**GEOLOGIC FEATURES AND THEIR
POTENTIAL EFFECTS ON CONTAMINANT
MIGRATION, SANTA SUSANA FIELD
LABORATORY**

Howard G. Wilshire, Ph.D.

October 5, 2006

Exhibit 1. Drawdown contours (in feet) from water extraction, 1954-1997 in the northeastern part of the SSFL. From L. P. Smith (Haley & Aldrich), Appendix B, Conceptual Site Model, Santa Susana Field Laboratory, Hydrogeology Summary Report (April 2000), Figure 1.9.

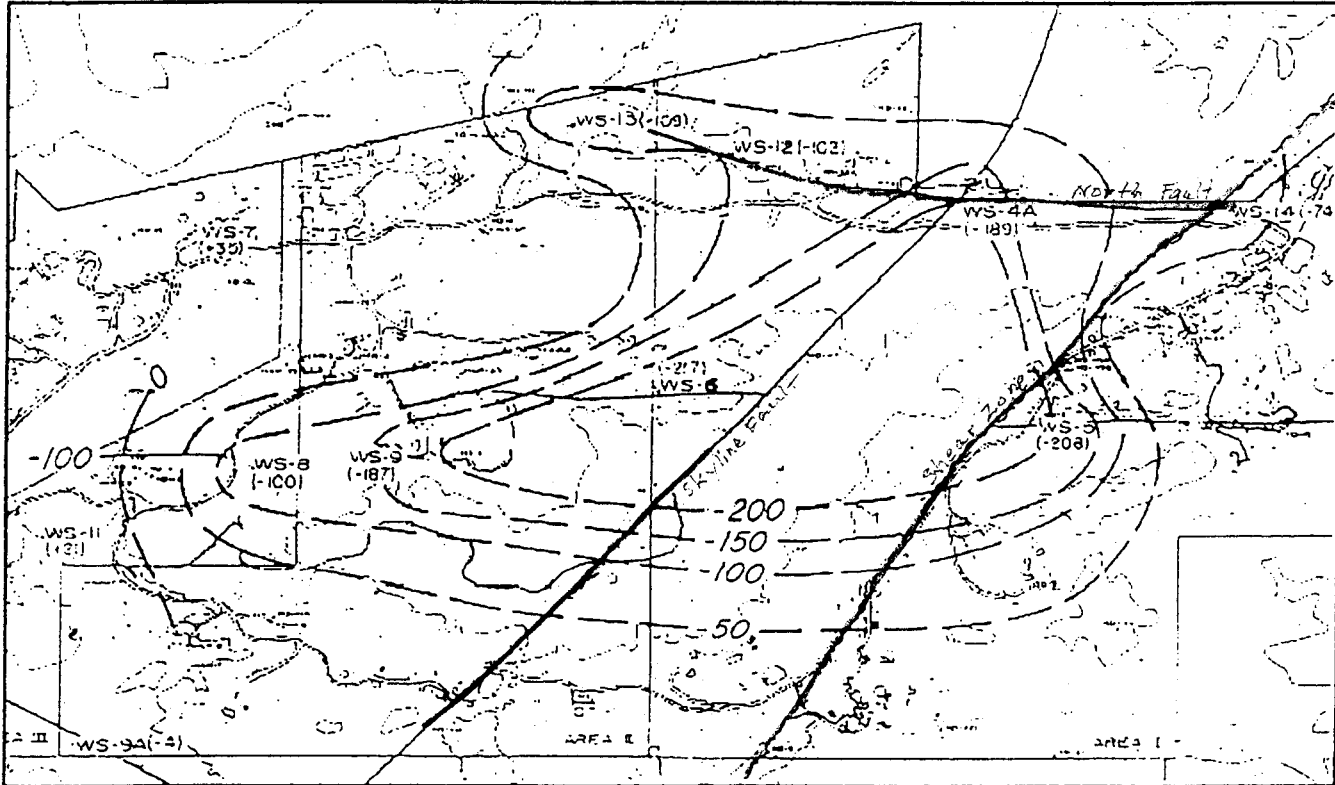
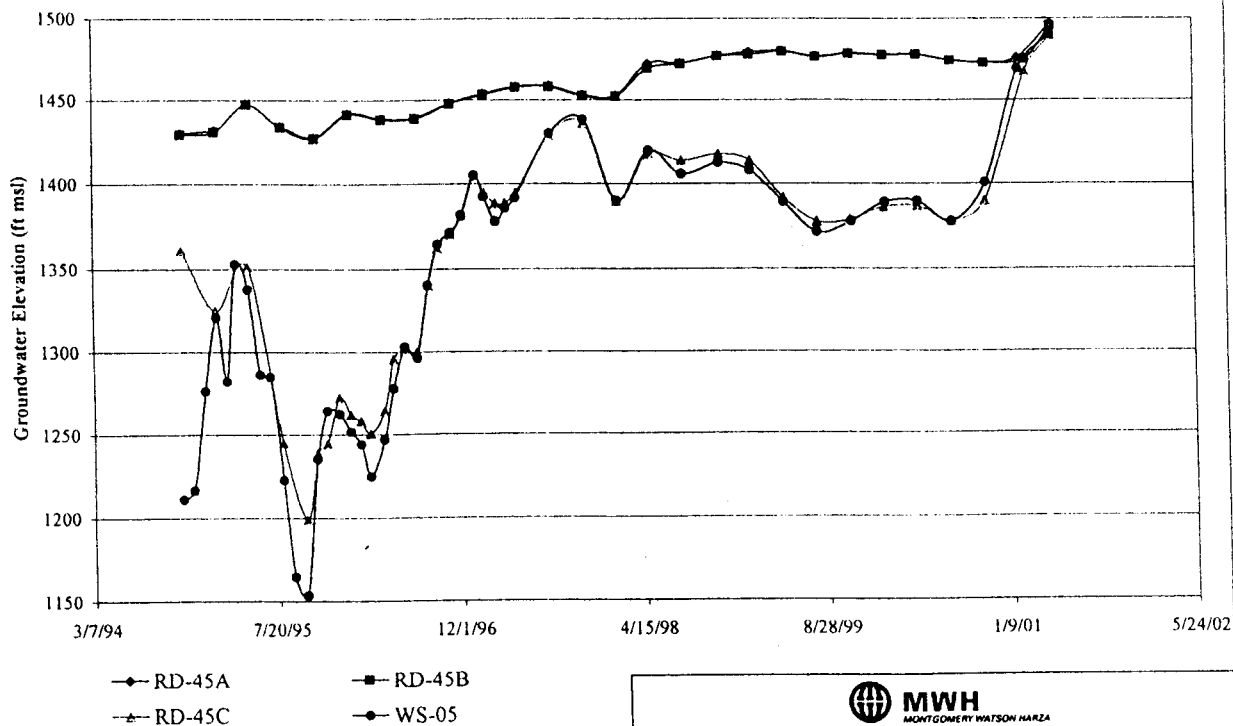
from the fault is not clear. Rates of response through the different kinds of fracture systems (clusters of steep fractures in the fault zone) and discontinuous, complex joint and stress fracture systems may cloud pump testing results. This is consistent with the behavior of wells WS-4A, WS-12, and WS-14 in the 1996 hydraulic communications study.⁷⁶ These wells did not respond immediately to shutdown of WS-6, but water levels in those wells (see Exhibit 3 for well locations) began to rise five to seven days later. This was true also of WS-13, but it could have been responding to RD-9 as well as WS-6. The drawdown pattern shown in Exhibit 1 also supports North Fault as a groundwater conduit.

Exhibit 3. Portion of SSFL, showing locations of wells WS-5, RD-73, RD-38A, B, and WS-14, and current locations of faults. From MWH, Near-Surface Groundwater Characterization Report, Santa Susana Field Laboratory (November 2003), Figure 2-9.

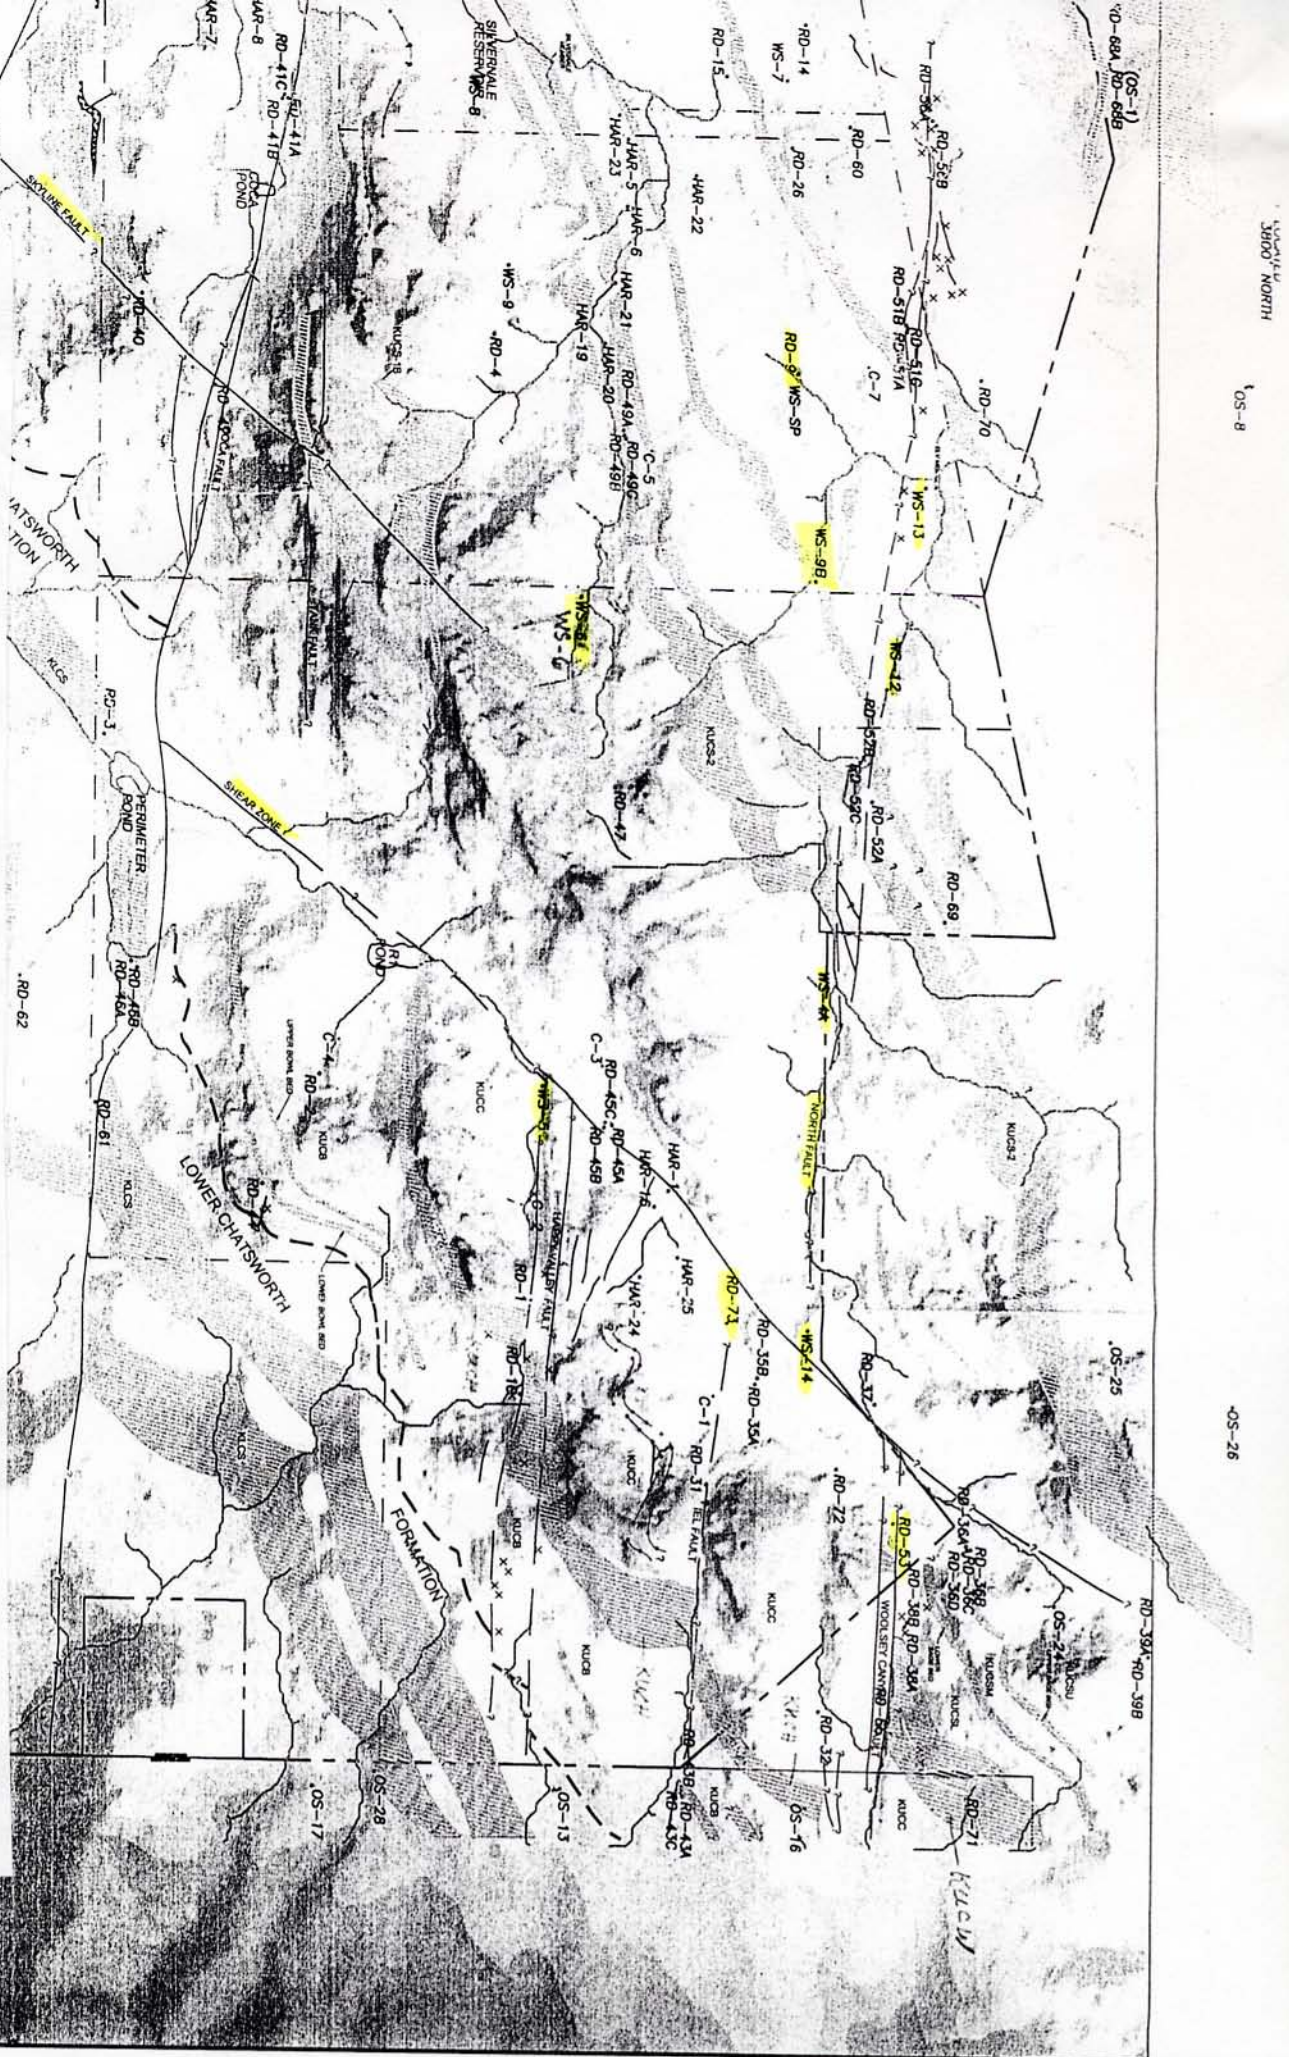
The lack of response of WS-14 to a 90-day pump test of RD-73, located on opposite sides of the Shear Zone is further taken as evidence that the Shear Zone is an aquitard.⁶⁷ This may well be the case, but until WS-14 is precisely located with respect to the full extent of the Shear Zone and RD-73 is precisely located with respect to the IEL Fault, this will remain uncertain. That conditions in the vicinity of WS-14 are complex is shown by the RD-38 cluster, which is closer to WS-14 than is RD-73. RD-38A did not respond to a pump test of the adjacent RD-38B (see Exhibit 3). This unexpected result is explained by the presence of a hypothetical gouge zone, which was not observed on video logs, between the two wells.⁶⁸ To compound the uncertainties, the log of RD-53, located in the Woolsey Canyon Fault Zone that separates RD-73 and the RD-38 cluster, does not mention any fault-related features.⁶⁹

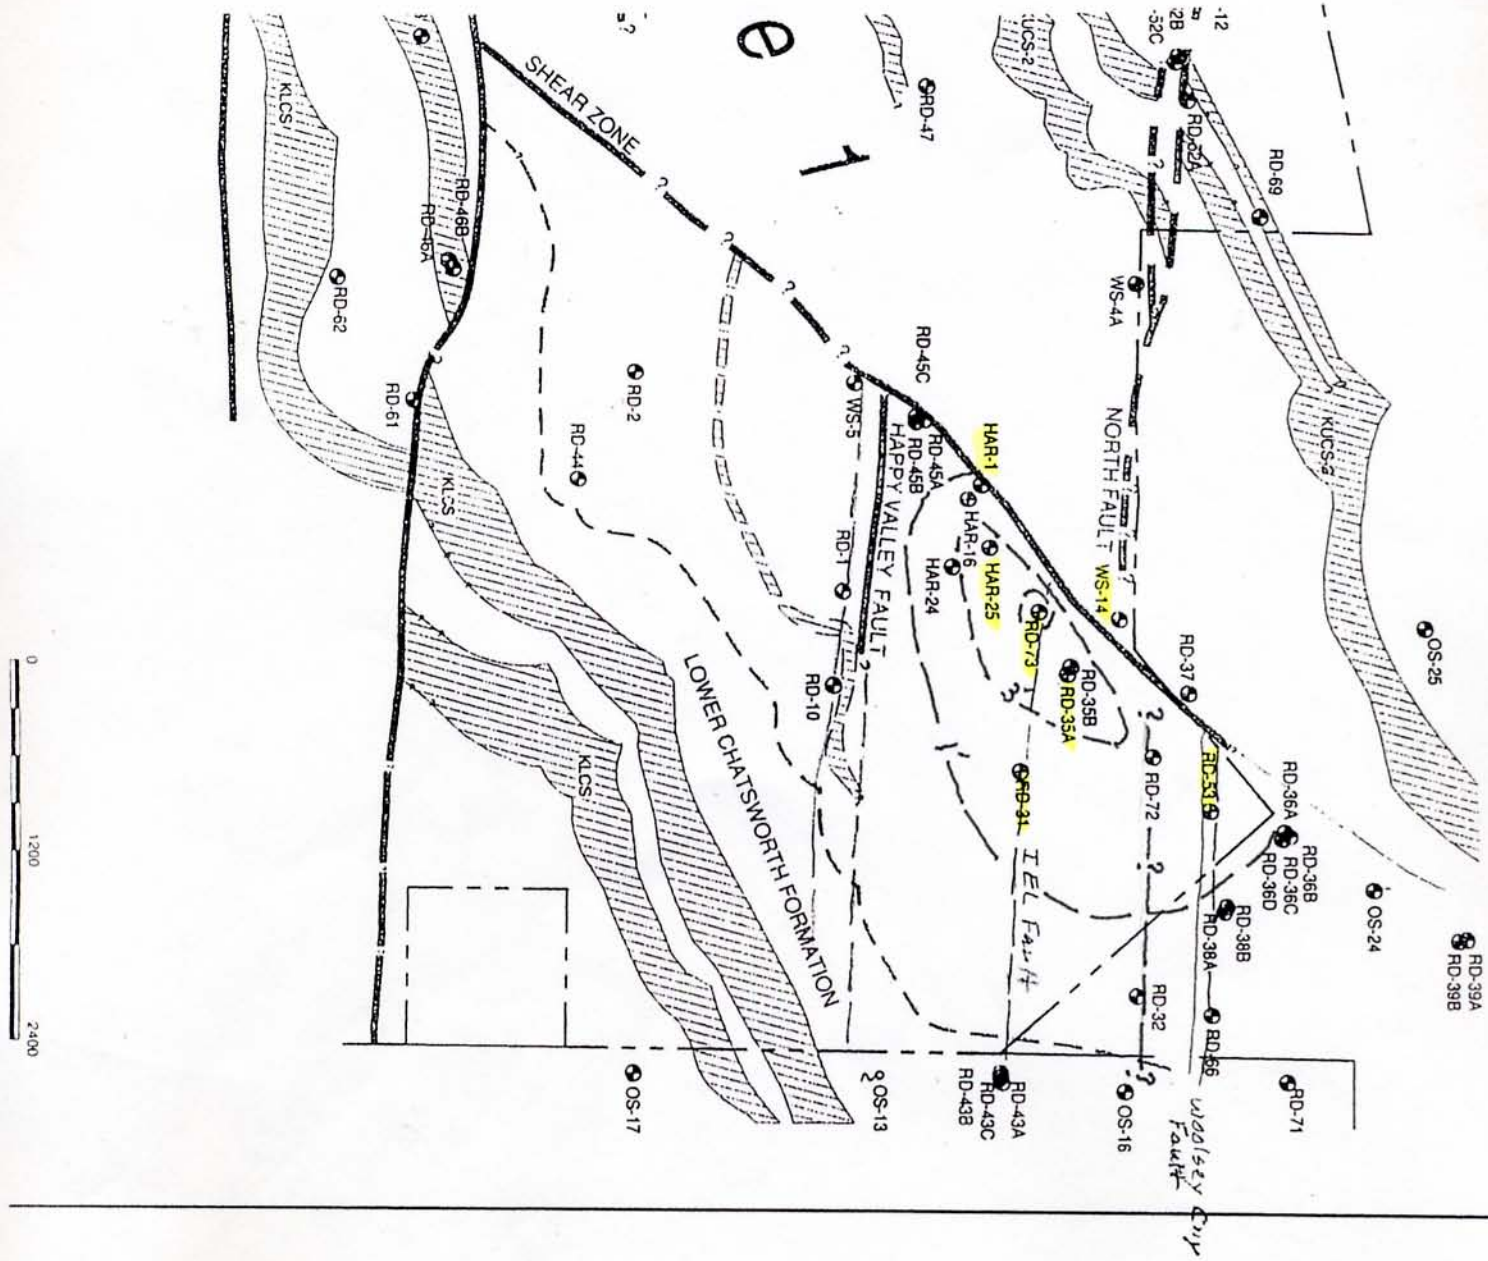
Contours representing drawdown from the RD-73 pump test are shown in Exhibit 4. The contours are interpreted to indicate an apparent rise in hydraulic conductivity about parallel to strike of the Chatsworth Formation, and that "drawdown appears to truncate at the shear zone to the west, and at the Happy Valley Fault to the south."⁷⁰ This is based solely on the behavior of WS-14 (discussed in the previous paragraph) because no other wells west of the Shear Zone were monitored, and there is no control for designating the relationship of drawdown to the Happy Valley Fault. Representation of the contours as crossing the subsequently recognized IEL and Woolsey Canyon Faults without deflection does not prove that they are not aquitards, but rather there is no control for the location of the contours—that has not changed since the contours were drawn or the faults were mapped. A possible E-W fault passes very close to RD-72 and RD-32 between the Woolsey Canyon and IEL faults.⁷¹ The presence of a fault in this area is supported by the video log of RD-32,⁷² which logs a number of broken zones; a log of RD-72 is not yet available.

72. Among the problems with this interpretation is the lack of information of where RD-72 may be located with respect to a possible fault in close proximity to RD-72 (see Exhibit 4). In addition, RD-72 has a history of sporadic TCE detects, at times showing no contamination.⁸⁰ As shown in Exhibit 4, drawdown contours for a pump test of RD-73, and in Exhibit 5, water level contours for Groundwater Unit 1a as recognized in 2000, the contours pay no attention to faults, including the Woolsey Canyon Fault Zone, the IEL Fault, and the possible fault near RE-72, not recognized at that time. However, no new data that would discredit the interpretations represented by the contours have been made available subsequently. Thus, the role of the Woolsey Canyon Fault Zone as an aquitard is putative.

Representations of drawdown contours from a pump test of RD-73 (Exhibit 4) and of water levels in Groundwater Unit 1a (Exhibit 5) do not show any effect of the then-unrecognized IEL Fault, but no new data have been provided to show the contours to be wrong.

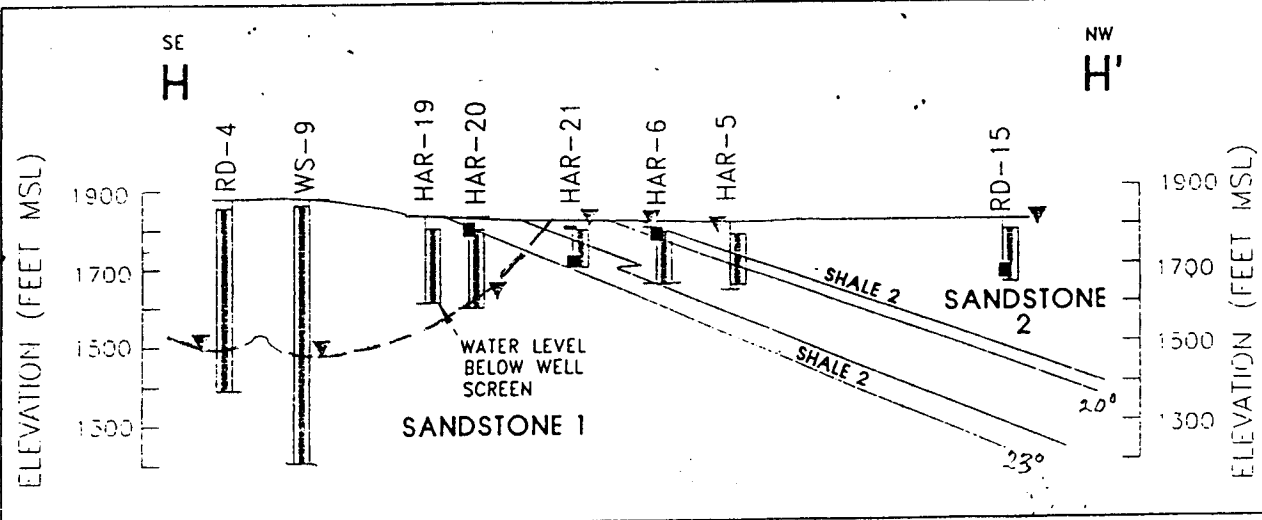
Exhibit 6 illustrates the case that Shale-2 acts as an aquitard between Sandstones-1 and -2 (old designations), as seen in water levels in wells RD-4, WS-9, HAR-19, and HAR-20 screened in Sandstone-1, and HAR-21, HAR-6, HAR-5, and RD-15 screened in Sandstone-2. Wells RD-4 and WS-9 are pumped wells with water levels governed by long-term extraction. Wells screened in Sandstone-2 are about 200 to 300 feet higher than those screened in Sandstone-1. It should be noted that the section in Exhibit 6 is viewed toward the south, contrary to normal practice.⁹⁵ The section does not position HAR-20 and HAR-21 consistently with the rather complex representation of Shale-2 in Fig. 2-9 of the Near-Surface Groundwater study. In addition, the well distribution is a shotgun pattern, but no information is given on how the wells were projected to the section line. It also is not clear why other wells in the area were not used to assess the water level differences—wells not used that might represent Sandstone-1 conditions include RD-49A, RD-49B, RD-49C, and C-5, and those that might represent Sandstone-2 conditions, but which were not used, include HAR-22, HAR-23, and RD-16.

An unassessed alternative to the interpretation that Shale-2 in this particular area is acting as an aquitard is shown by the dashed line drawn in on the section line of Exhibit 6. This is meant to indicate the possibility that the water levels in HAR-19 and HAR-20 are on the side of a drawdown cone produced by pumping of RD-4 and WS-9. The drawdown cone could intersect

the ground surface east of the wells screened in Sandstone-2 and thus not have affected their water levels.

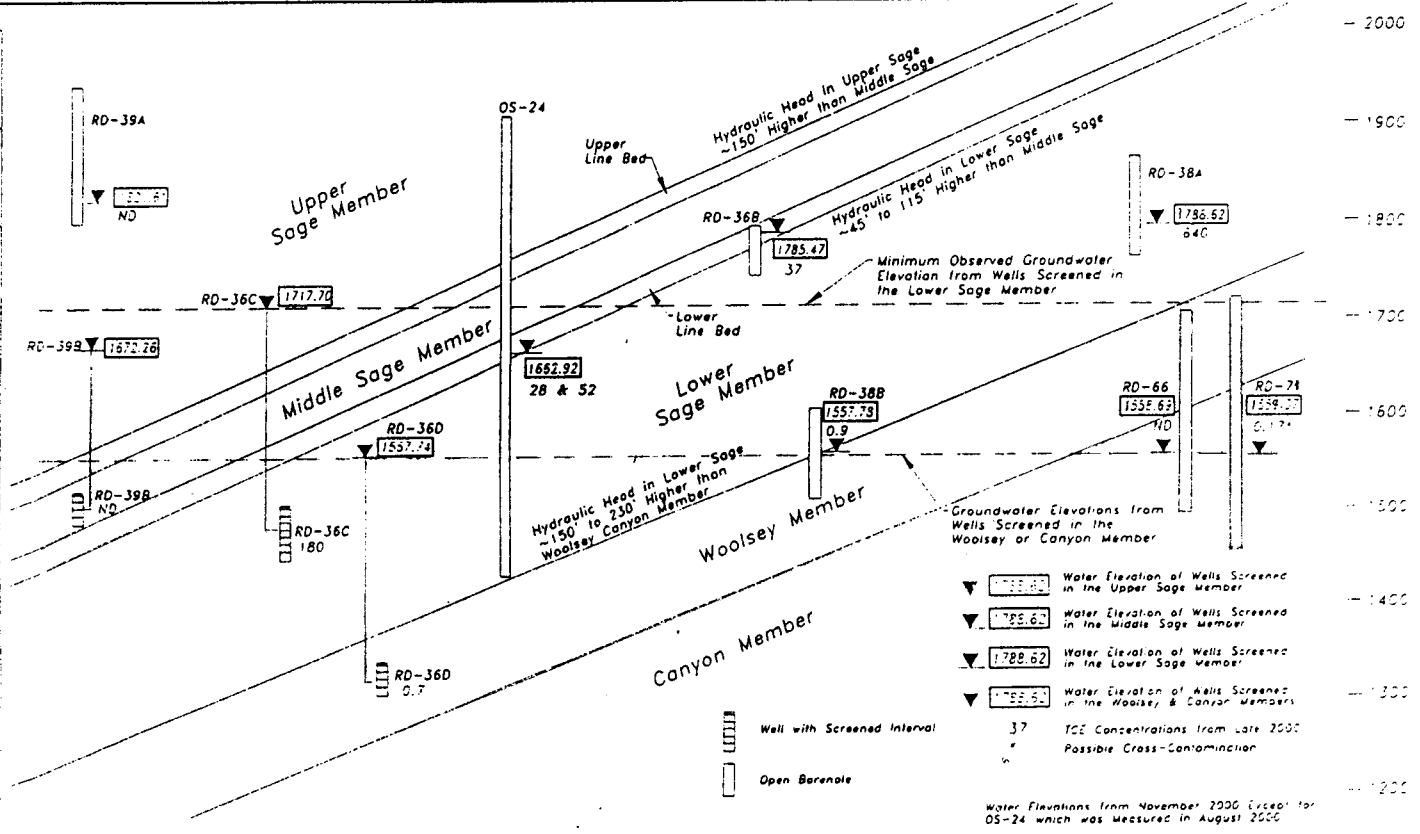
Support for the Upper Line Bed being an aquitard is found in the 150 foot difference in hydraulic head of RD-39A and RD-39B. RD-39A is screened solely in the Upper Sage Member and RD-39B solely in the Middle Sage Member. The Upper and Middle Sage Members are separated by the Upper Line Bed. A pump test of RD-39B did not affect the water level in RD-

39A, lending further support to the Upper Line Bed being an aquitard.¹⁰⁰ Since RD-39A is the only well screened solely in the Upper Sage, this provides only a very skimpy basis for assessing the broader role of the Upper Line Bed; moreover, there are only two wells, one periodically dry, screened solely in the Middle Sage (RD-39B and RD-36A). Because of the proximity of RD-39A and B to the Shear Zone, more confirmatory evidence is needed to assess the role of the Upper Line Bed. The pump test may or may not be significant, considering the similar behavior of RD-38A and RD-38B and the lack of tangible evidence of separation by an aquitard (described in connection with the Woolsey Canyon Fault Zone above), and the behavior of the Lower Line Bed described below.
